Device **C164CI-8E**
Marking/Step **Step ES-DA, DA**
Package **C-MQFP, P-MQFP-80**

This Errata Sheet describes the deviations from the current user documentation. The module oriented classification and numbering system uses an ascending sequence over several derivatives, including already solved deviations. So gaps inside this enumeration can occur.

Figure 1 Critical Event

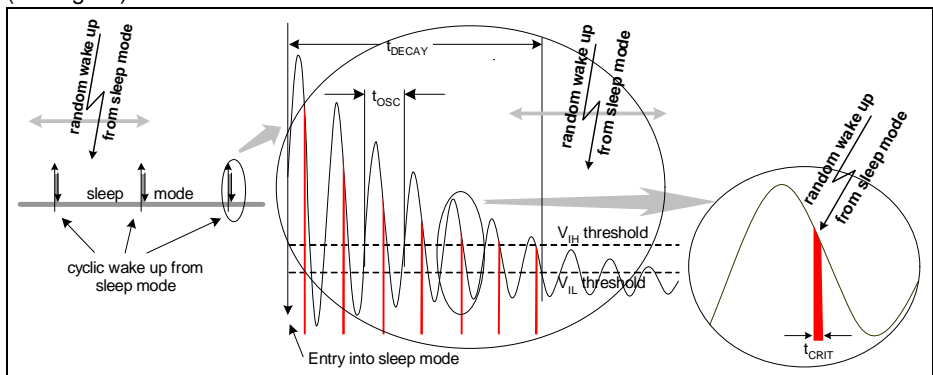
POWER.22 Wake up from Sleep Mode in Oscillator Decay Time

Due to a synchronization problem, the device may not correctly wake up from sleep mode if an asynchronous external wake up trigger occurs already in the oscillator decay time, i.e. in a particular time window before the device has actually entered sleep mode (see figure)

2. the IDLE instruction to enter sleep mode has been executed, i.e. the main oscillator is in the oscillator decay time (typically ~ 160 µs decay time for a 16 MHz crystal, ~ 2 µs for a 16 MHz ceramic resonator)
3. the external wake up trigger signal (fast external interrupt or signal on pin $\overline{\text{NMI}}$) coincides with the critical time window (t_{CRIT}) of each oscillator cycle during the decay time of the clock signal at pin XTAL1 (critical times shown in red in figure)

The problem occurs only in the decay time of the main oscillator and in a very small window around the clock edge at XTAL1 (t_{CRIT} is about 5 ps wide).

Workarounds:

- Select RTC on in sleep mode (SYSCON1.SLEEPCON = 01_B).
For devices with auxiliary oscillator (e.g. C161CS), select main oscillator as clock source (SYSCON2.RCS = 0).
- Avoid a wake up during the main oscillator decay time

Figure 2 SSCTB Timing

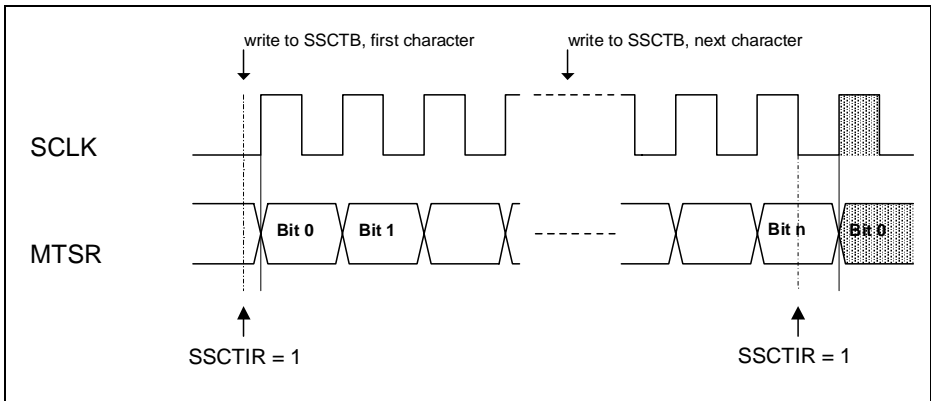
SSC.H2 Timing of flag SSCTIR (SSC Transmit Interrupt Request)

In master mode, the timing of SSCTIR is as follows:

When SSCTB has been written while the transmit shift register was empty (and the SSC is enabled), flag SSCTIR is set to '1' directly after completion of the write operation, independent of the selected baud rate. When the transmit shift register is not empty when SSCTB was written, SSCTIR is set to '1' after the last latching edge of SCLK (= 1/2 bit time before the first shifting edge of the next character). See also e.g. C167CR User's Manual V3.1, p. 12-5.

The following diagram shows these relations in an example for a data transfer in master mode with SSCPO = 0 and SSCPH = 0. It is assumed that the transmit shift register is empty at the time the first character is written to SSCTB:

Typically, in interrupt driven systems, no problems are expected from the modified timing of flag SSCTIR. However, when flag SSCTIR is polled by software in combination with other flags which are set/cleared at the end or at the beginning of a transfer (e.g. SSCBSY), the modified timing may have an effect.

In order to achieve a defined and systematic behavior with all device steps, the SSC receive interrupt, which is generated at the end of a character transmission, may be used instead of the SSC transmit interrupt.
